R. T. HICKS CONSULTANTS, LTD.

September 26, 2011

RE: Response to MMD Technical Comments

Plate 2
June 29, 2011

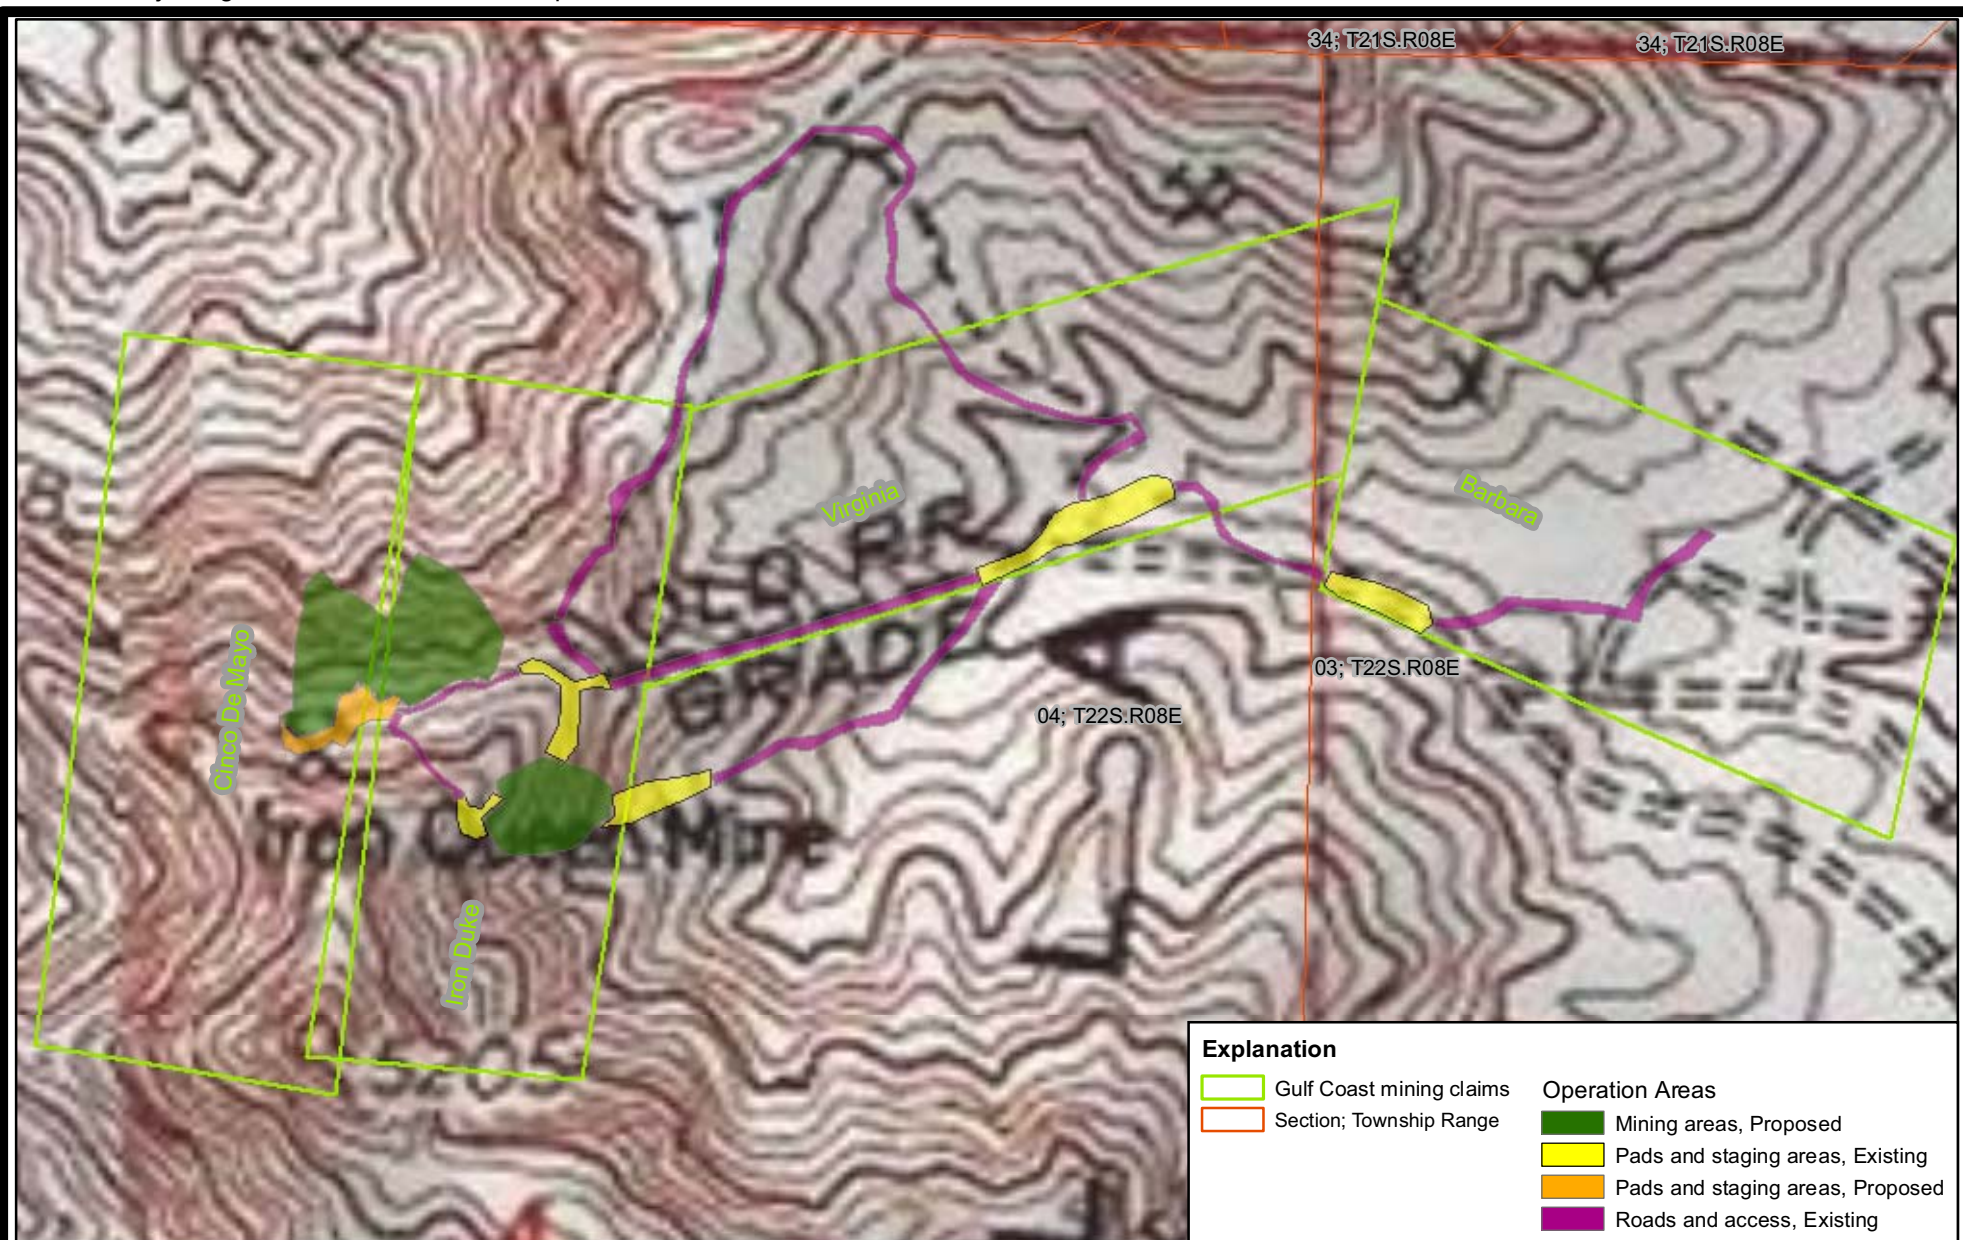
- 2. Pursuant to 19.10.304.D.2 NMAC, please amend Plate 2 and/or Plate 3 (maps) to include the boundaries of the proposed permit area, all previously disturbed areas, ephemeral drainages, and the access route(s) that will be utilized to access the north waste piles. Note; during the agency site visit of August 1, 2011 access to the north waste pile is not in existence.**

- Boundaries of the four claims are shown in "lime green" on Plate 3A and Plate 2.
- All previously disturbed areas are included within Areas numbers 1 through 14 on plate 3A.
- Ephemeral drainages are the arroyos evident on the aerial photograph of Plate 3A. Topographic contours (in brown) are superimposed on the aerial photograph. The primary drainages are to the east with a smaller area draining to the north. These drainages are evident as "V's" pointing up the drainage on the topographic backdrop of Plate 2 and Plate 3A.
- Access to the North Side Waste Rock Pile will use Area 9 (Upper Access Road) and Area 5 (Cinco de Mayo Access and Upper Pad). This last Area was created and used
